ADDENDUM NO. 1

DATE: 8/25/11
TO: ALL PLAN HOLDERS
FROM: Aaron Stewart, P.E.

SUBJECT: Wittman Regional Airport, AIP 3-55-0061-27
Apron Reconstruction

SHEET: E12 OF E19

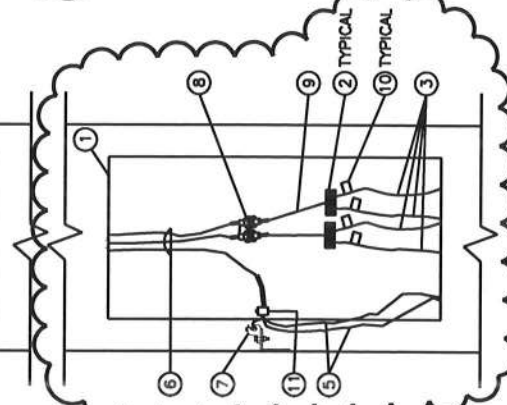
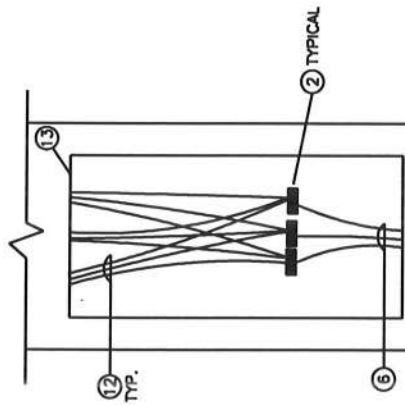
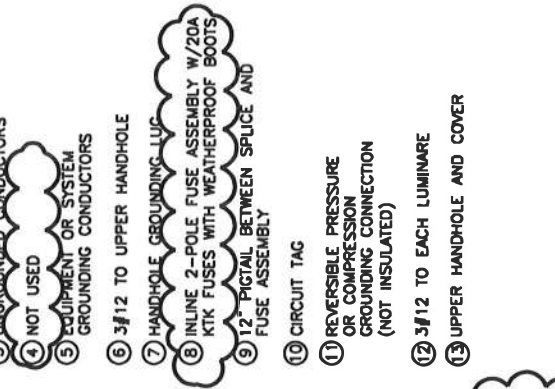
10. Pages E4, E12, and E19 of the electrical portion of the plan set have been modified. Please see the attached 8-1/2" x 11" sheets that denote the changes.
